3.5 Missile Protection

STP DEP 3.5-1 (Table 3.5-1 and Figure 3.5-2)

Figure 3.5-2 Low-Trajectory Turbine Missile Ejection Zone

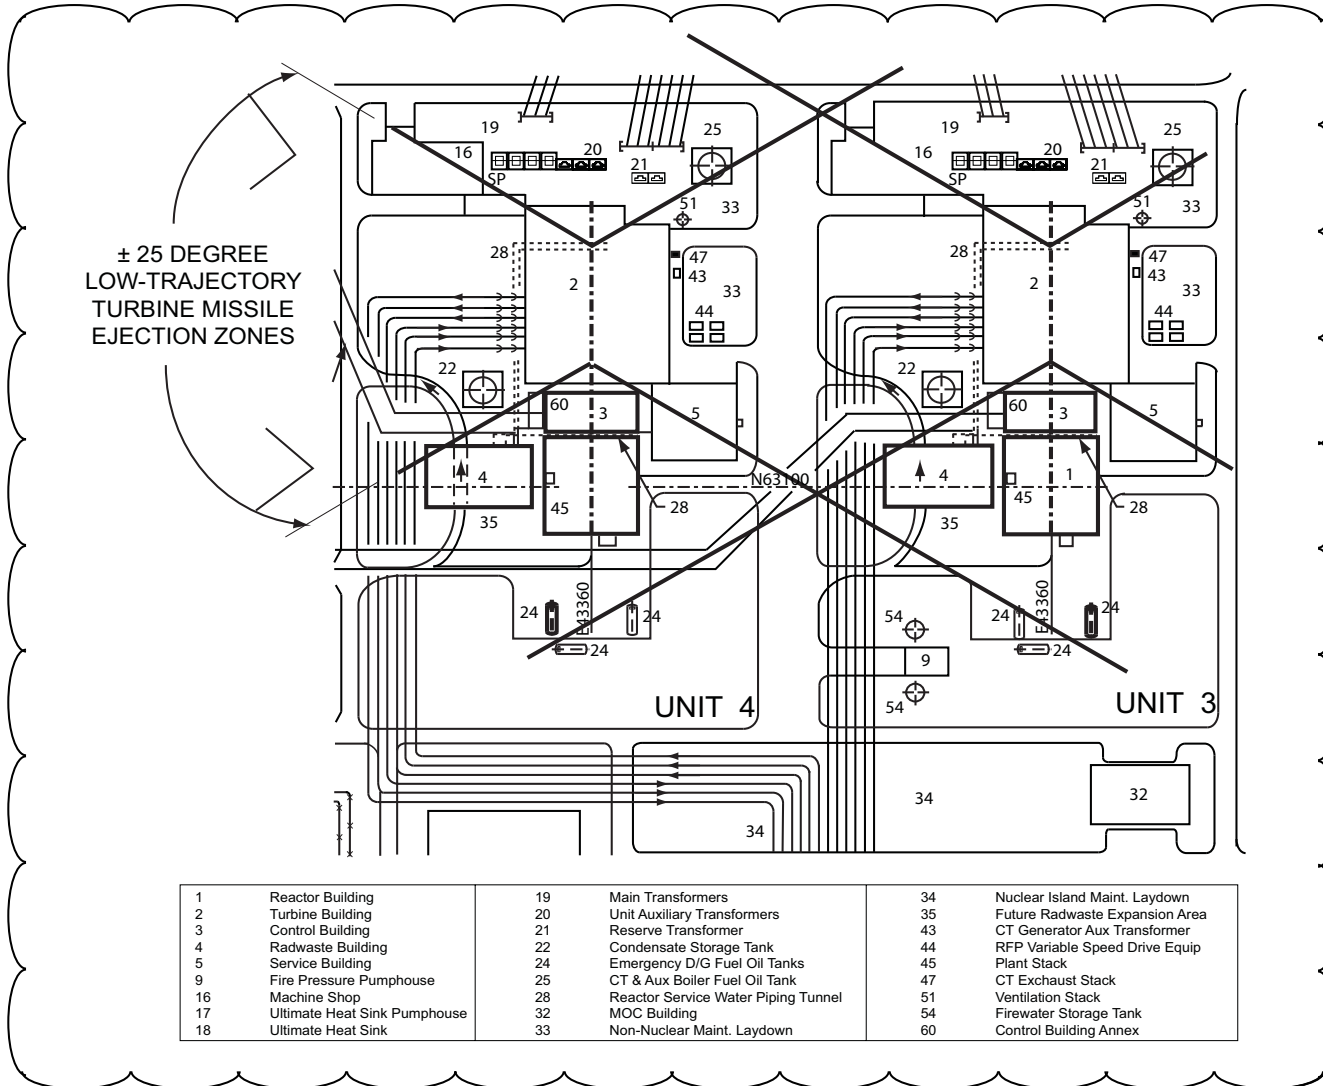
STP DEP 3.5-1

~~Acceptance Criteria 1 of SRP Section 3.5.1.3 considers a plant with a favorable turbine generator placement and orientation and adhering to the guidelines of Regulatory Guide 1.115 adequately protected against turbine missile hazards. Further, this criterion specifies that exclusions of safety-related structures, systems or components from low trajectory turbine missile strike zones constitutes adequate protection against low trajectory turbine missiles. The turbine generator placement and orientation of the ABWR Standard Plant meets the guidelines of Regulatory Guide 1.115 as illustrated in Figure 3.5-2.~~

The STP 3 & 4 turbine generator placement and orientation in relation to essential systems of the adjoining unit are illustrated on Figure 3.5-2. Per Regulatory Guide 1.115, the STP 3 & 4 turbine generator placement and orientation is considered unfavorable. Per Acceptance Criteria 1 of Standard Review Plan Section 3.5.1.3 for unfavorable turbine generators, a value of 10^{-2} per year per plant was chosen as a conservative value for the product of strike probability (P_2) and damage probability (P_3). The criteria for unfavorable turbine generator orientation given in Standard Review Plan Table 3.5.1.3-1 and provided in Table 3.5-1 was assumed for the missile generation probability (P_1). The resulting probability of unacceptable damage from a main steam turbine missile (P_4), which is $P_1 \times P_2 \times P_3$, is less than 10^{-7} per year per plant.

Therefore STP 3 & 4 main steam turbine generator placement and orientation meets the acceptance criteria of Standard Review Plan 3.5.1.3 and the guidelines of Regulatory Guide 1.115.
